STATE OF NORTH CAROLINA  
DEPARTMENT OF TRANSPORTATION

Subject: **Application for Section 404 and 401 Permits;** Hope Mills Bypass from SR 1141 (Bingham Drive) to SR 1363 (Elk Road), Cumberland County, Division 6, TIP No. U-0620, State Project No. 8.1442601, Federal Aid No. STP-0622(2), \$475.00 Debit work order 8.1442601, WBS Element 34408.1.1

**Subject:** Minutes of the Interagency Permit Drawing Review Meeting held on August 22, 2002 for U-620, Cumberland County  
*February 3, 2003 TCE Responses*

PLAN VIEW  
SITE 1A

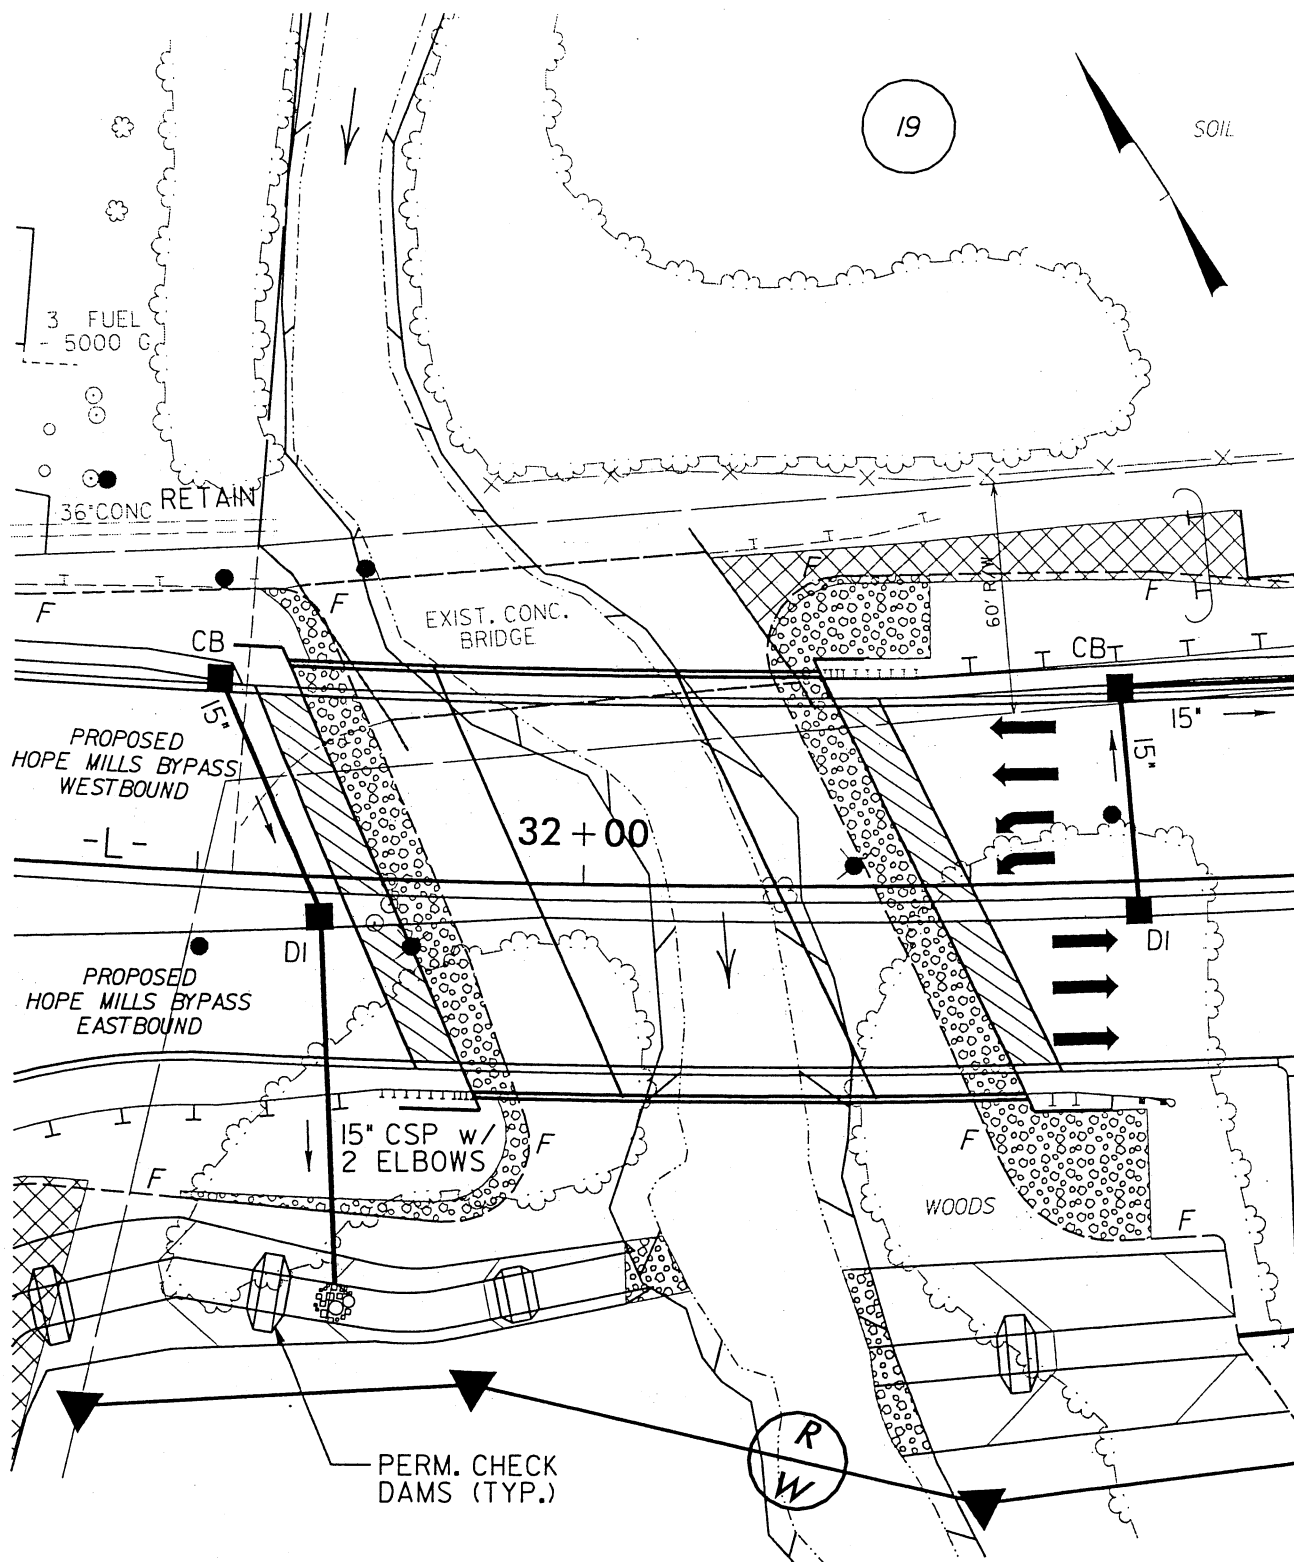
**Sheet 5 (of plans):** Drawings should be provided for bridge although there should be no impacts associated. Embankment riprap should also be shown at this site.  
*Comments incorporated, Site 1A.*

Site 1A. In accordance with the request from the 4C meeting, a permit drawing has been included (sheet 3 of 27) that reflects no jurisdictional impacts and the placement of riprap along the embankment.

# PLAN VIEW SITE 1B

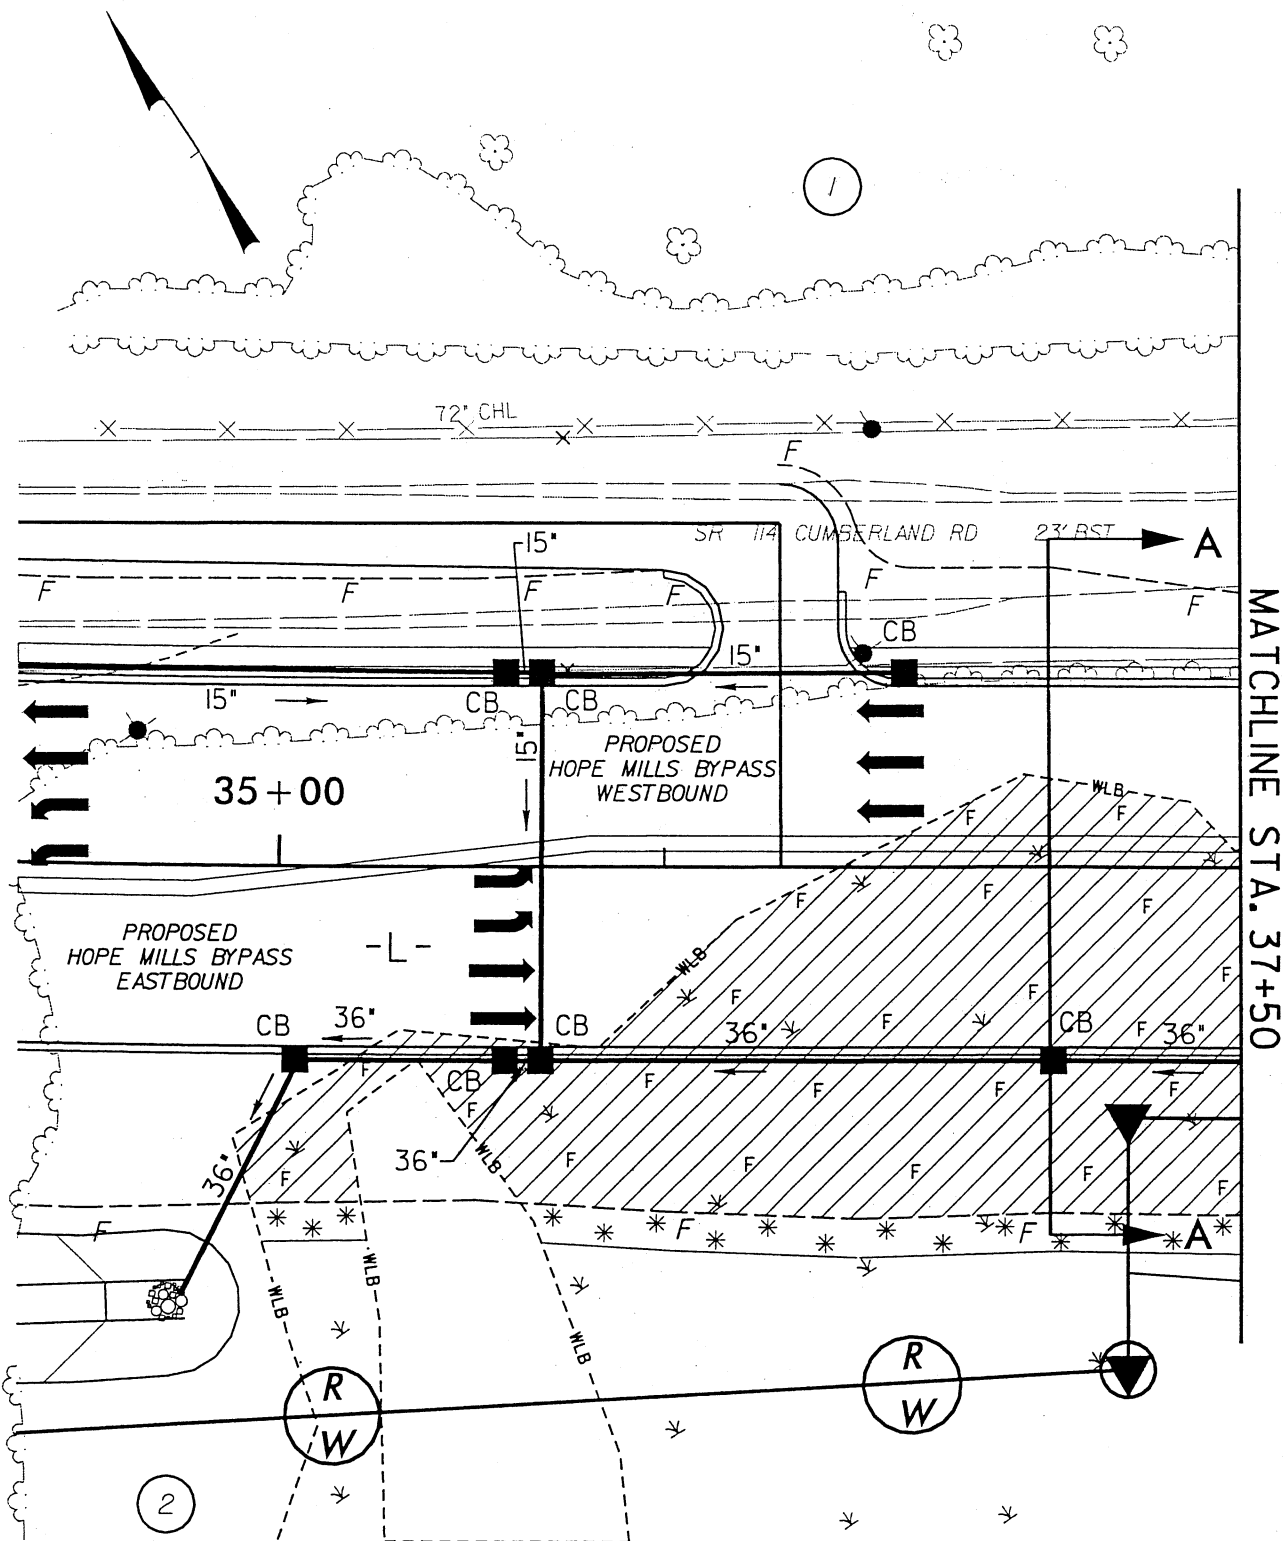
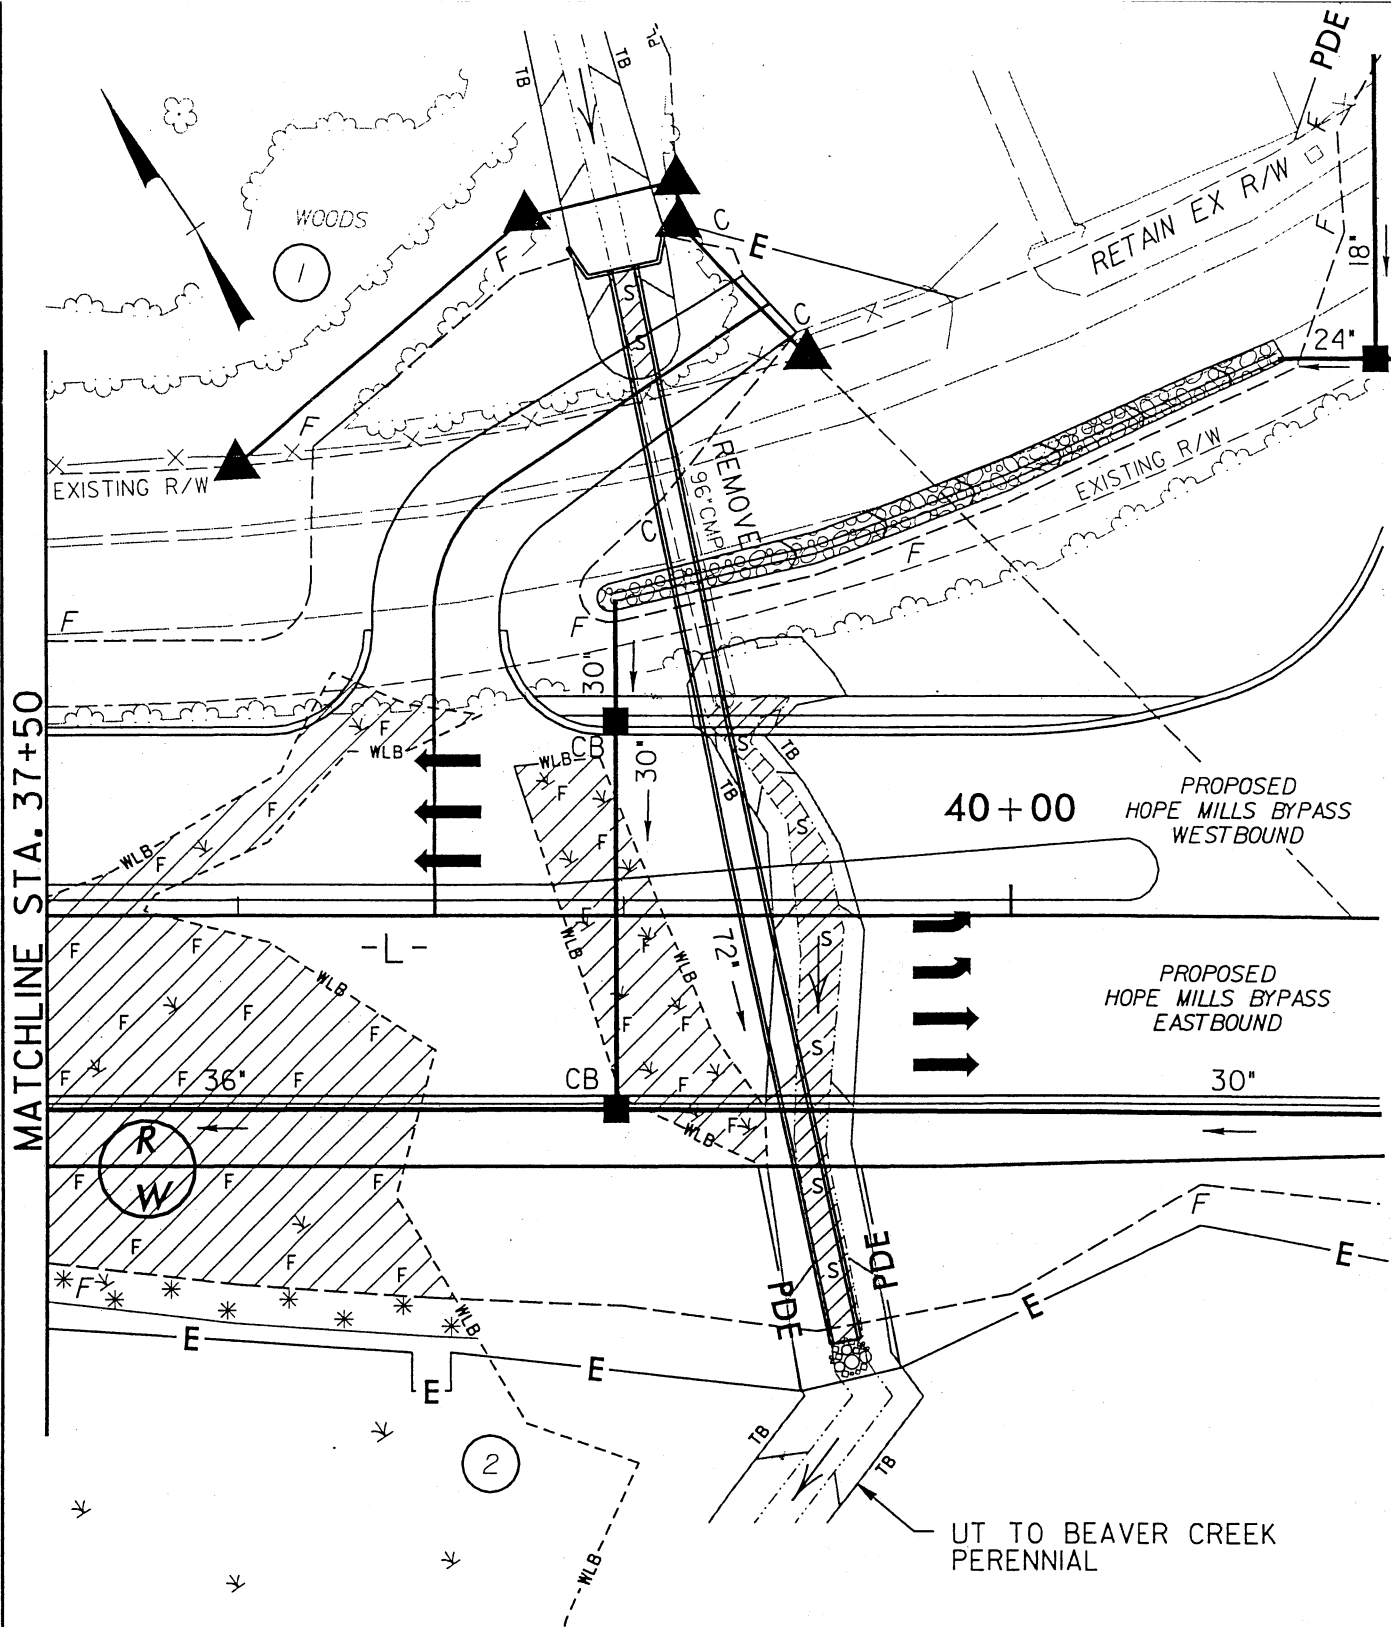
**Sheet 6 (of plans)/current Site 1:** Pipe should be buried 1'.  
*As discussed during review meeting, this pipe was designed to be buried 1.0'. Also, Site revised from Site 1 to Site 1B.*

**Sheet 6 (of plans):** Hennessy asked if we considered discharging outlet right of station 37+00 into the wetland. Marshall responded that with a 36" pipe, non-erosive velocities would not be obtained. Hennessy then confirmed that he likes the proposed design.  
*No action required.*

# PLAN VIEW SITE 3

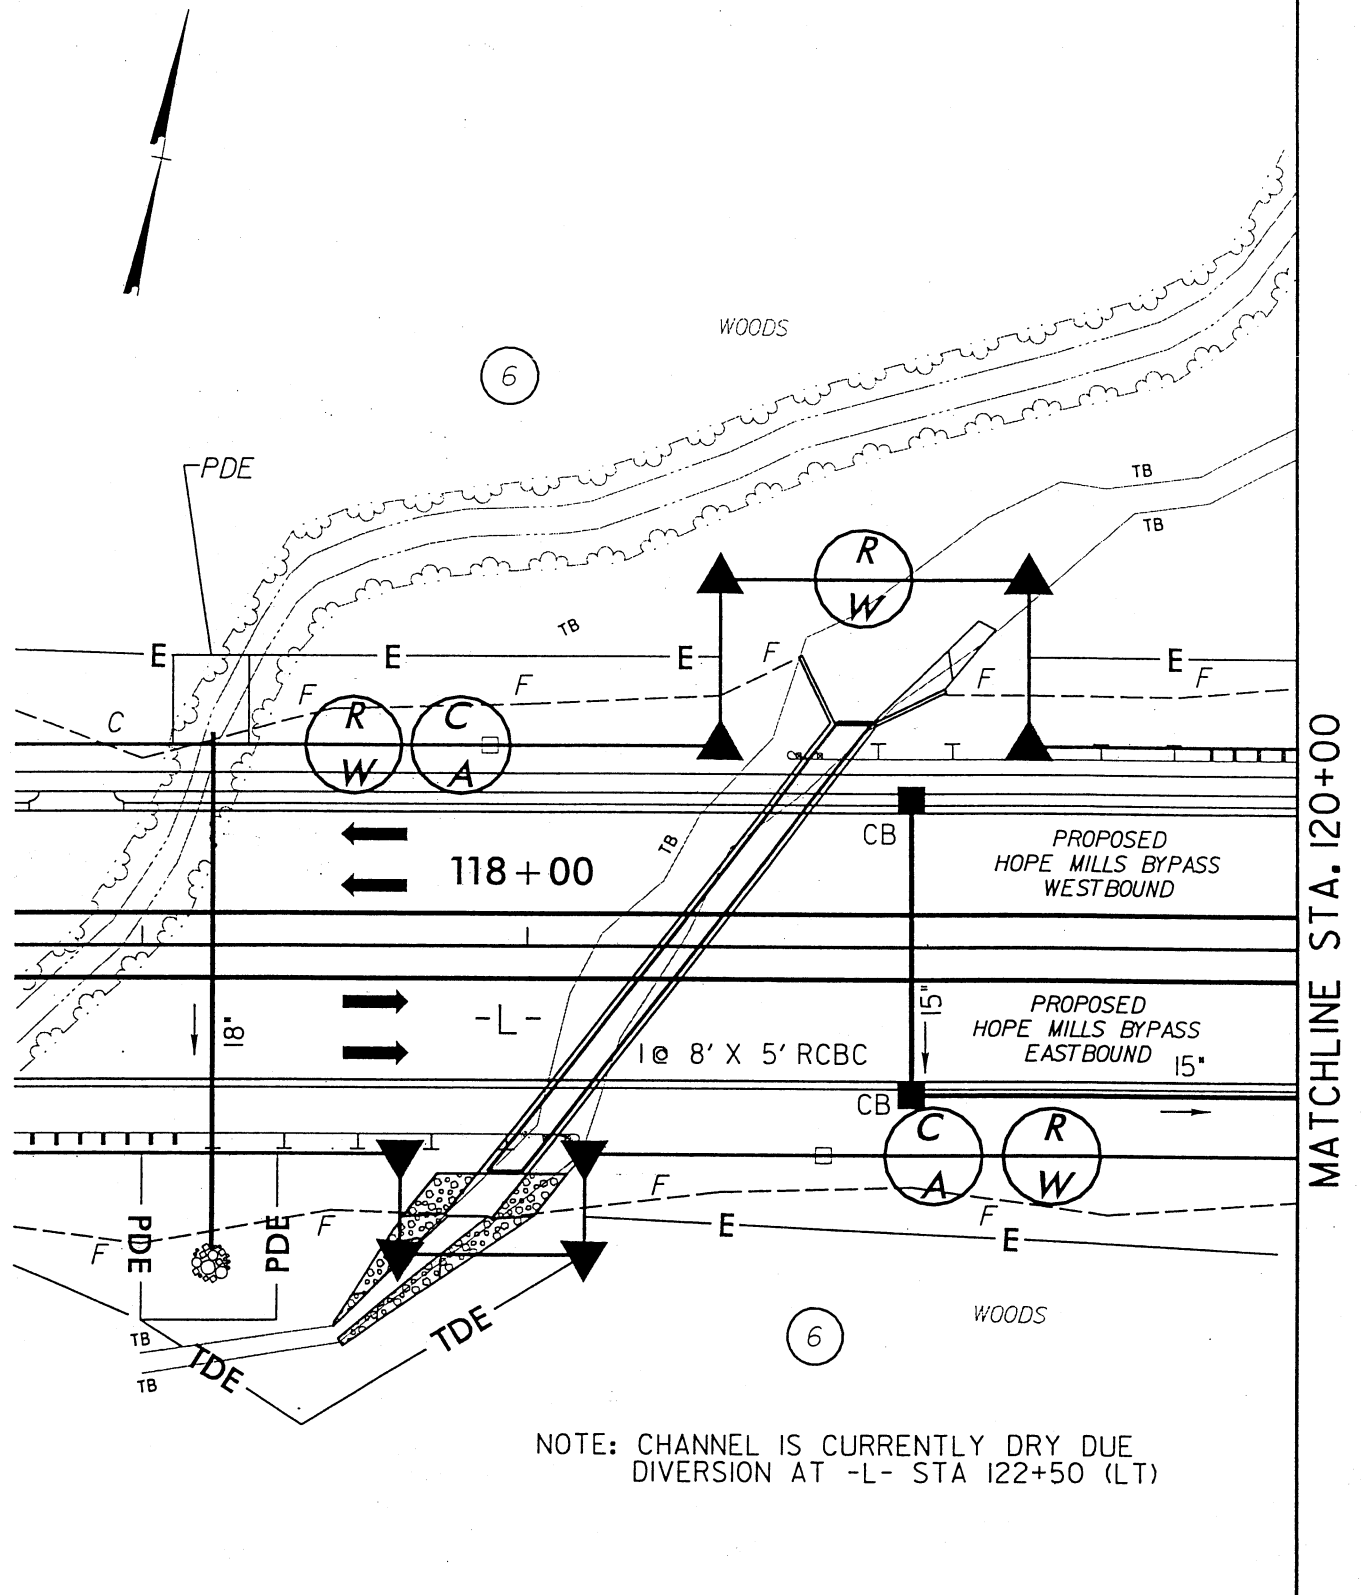
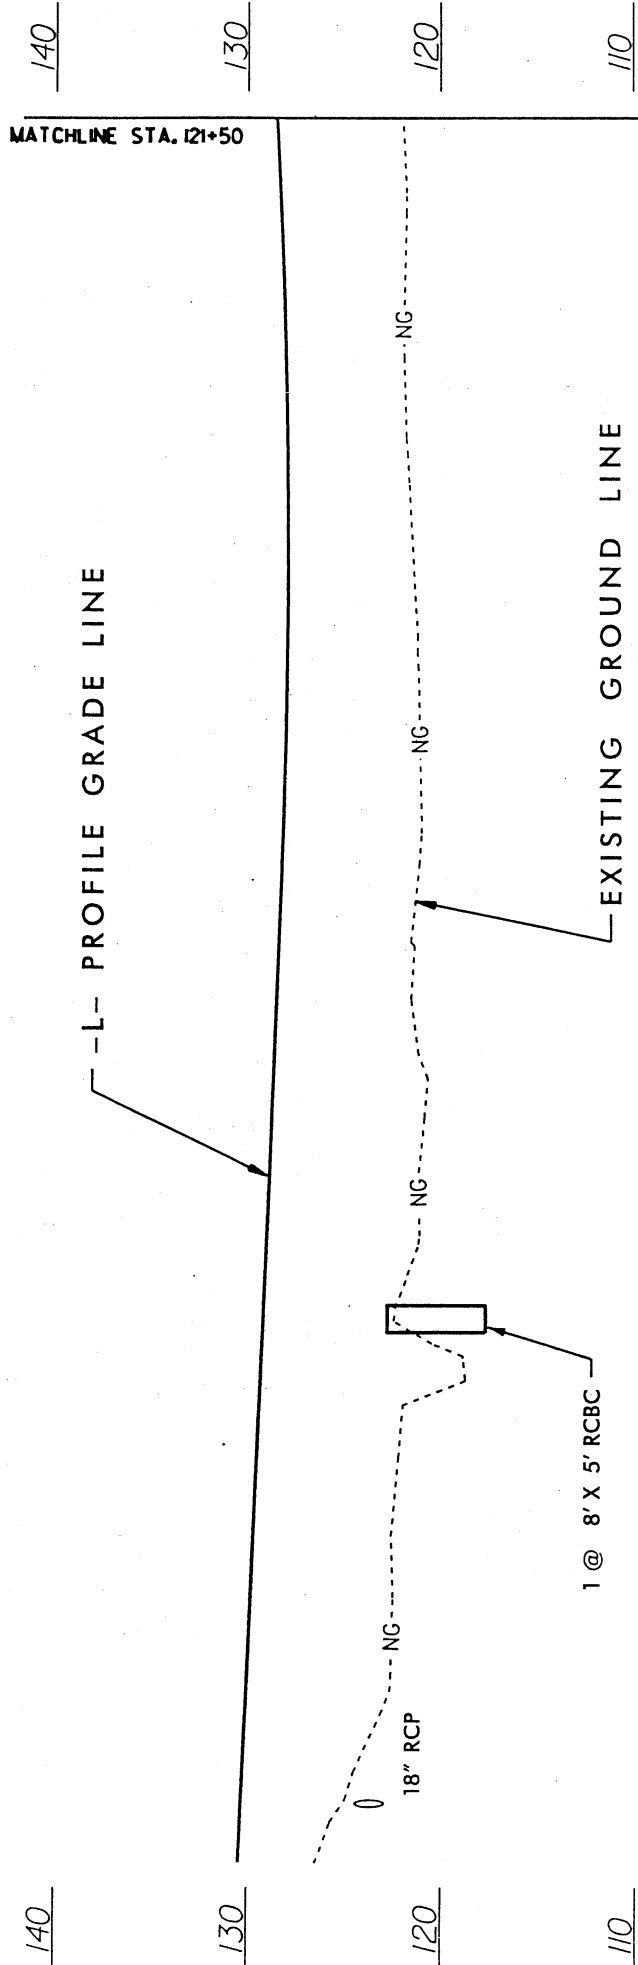
**Sheet 12 (of plans)/current Site 3:** Current design is favorable. Site is to re-establish previous flow pattern. Alterations have occurred due to sewer line installation. A site 3A should be created which shows old streambed and impacts at the box culvert location. Better clarify flow patterns, both existing and natural. Hennessy to discuss with his people about utility company's responsibility to correct.

***Comment incorporated. The limits of Site 3 have been expanded to show the approximate stream location and proposed RCBC crossing.***
